RE: Alden Resources, LLC., Area #6, Campbell County, Tennessee
OSM #3340 REVISION #6 APPLICATION-AS Built Certification for Pond #103

Alden Resources, LLC. Area #6 OSM #3340
Revision #6 Narrative
As Built Certification for Pond #103
Notification of Discontinuation of Mining

Alden Resources, LLC.
Area #6 OSM #3340
Pd 103 As Built

Pond #103 Plan View

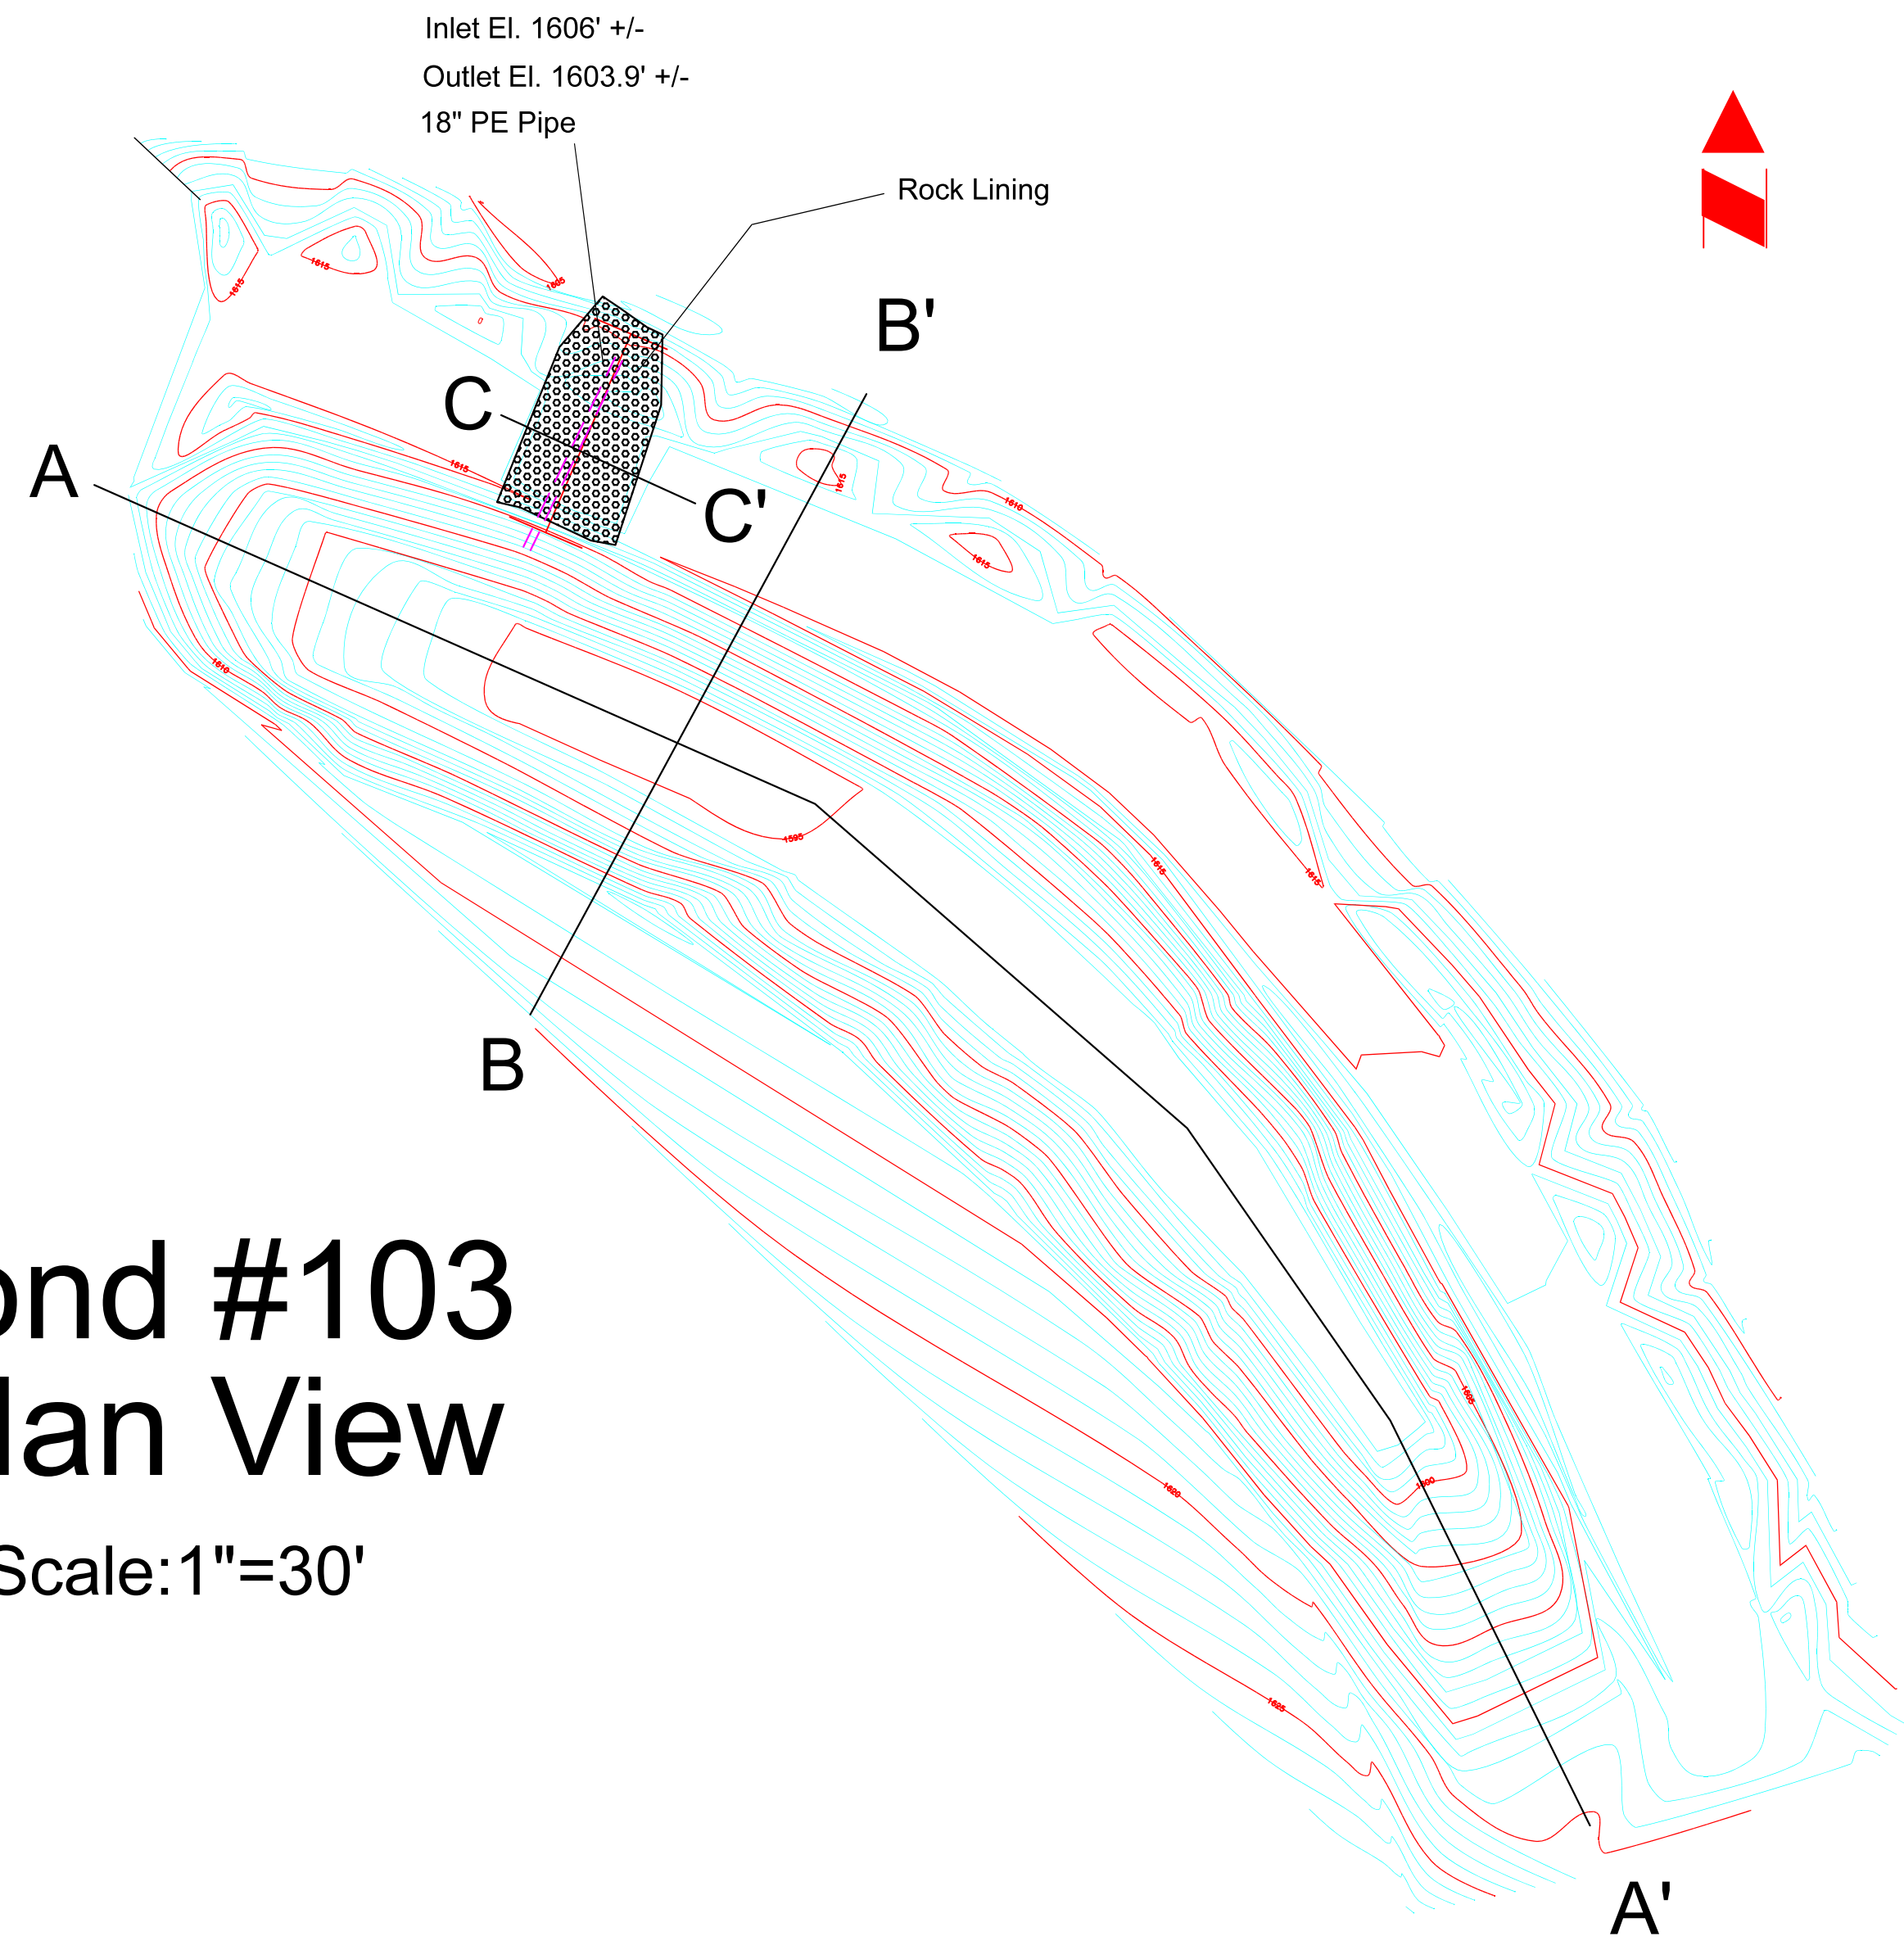
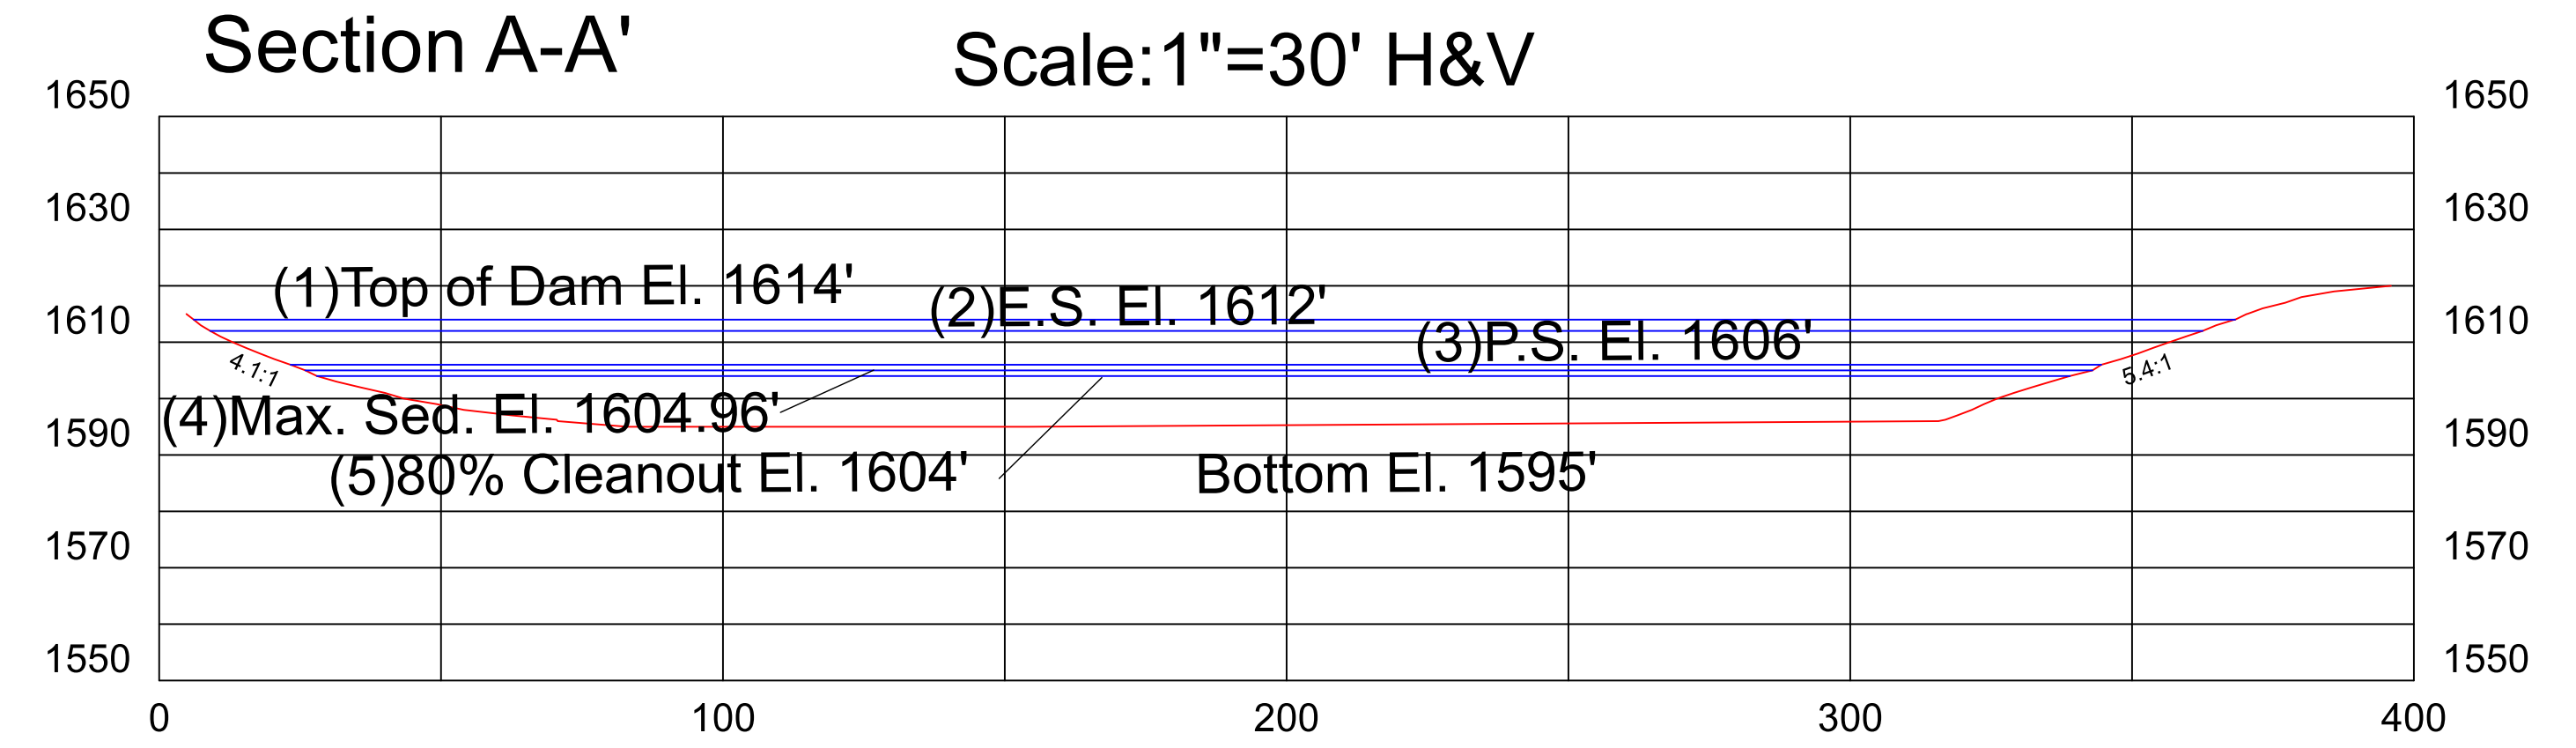
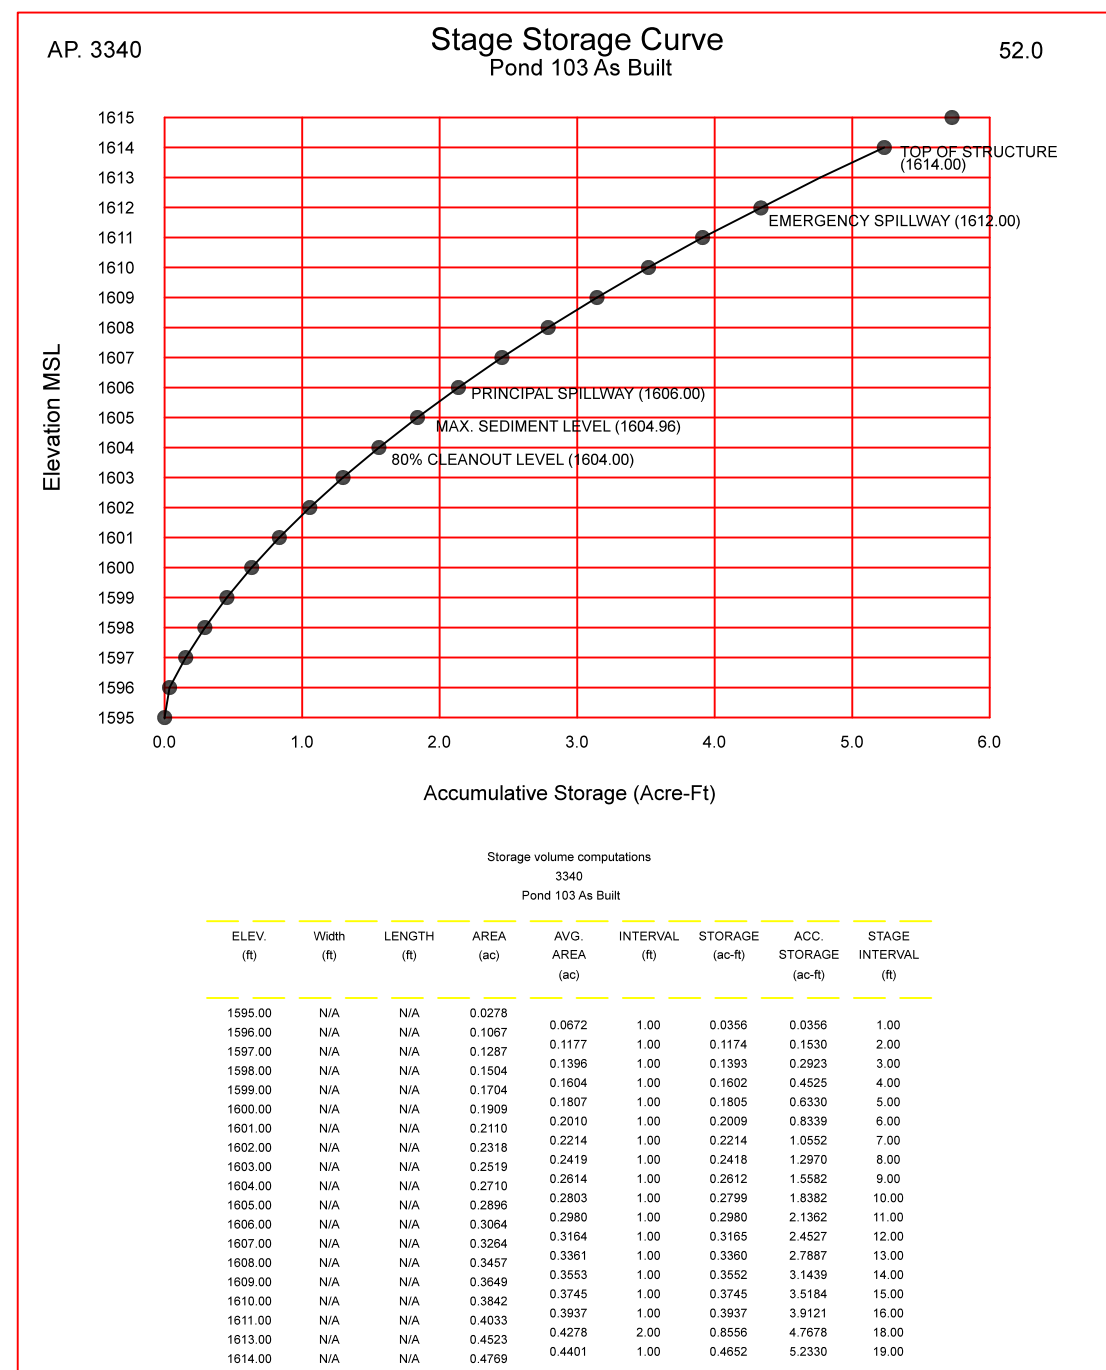
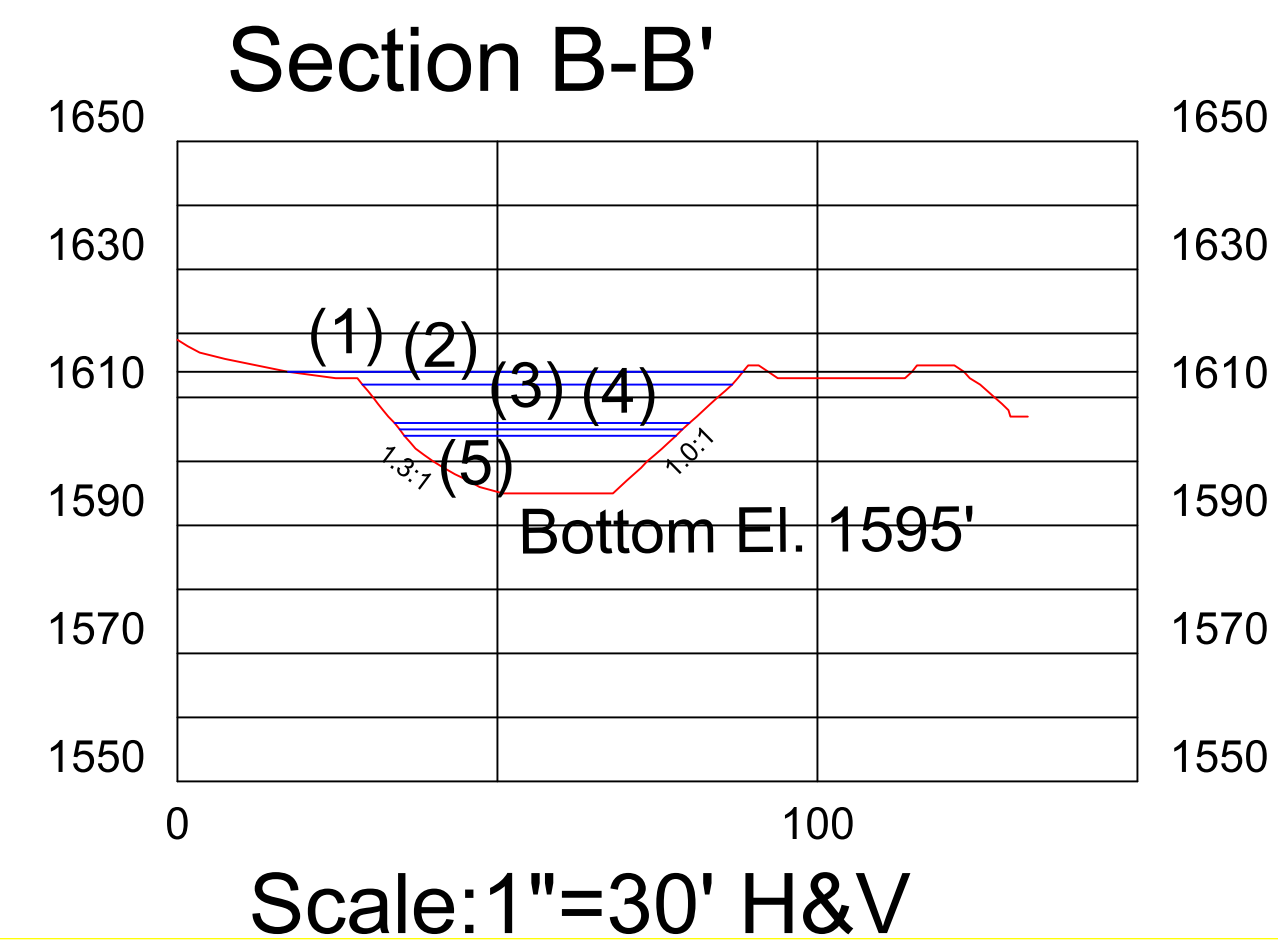
This revision is to complete the “as built” certification process for the above referenced pond. As discussed with OSM personnel on site, this revision also proposes to slightly increase the disturbed drainage area of pond #103 by about 2.1 acres. This small area captures the very end of the disturbance and eliminates the need to construct pond #104.

No additional mining will be done on this site once reclamation procedures are completed. Hence, pond #104 will remain on the map at its location even though its originally approved drainage area will be reduced by 2.1 acres which now will be contained in pond #103.

X The facility HAS NOT BEEN constructed in accordance with the design approved in this permit; or actual location or dimensions ARE NOT within accepted engineering tolerances for such facilities. (In this instance, submit 5 copies of a revision application with this certification).
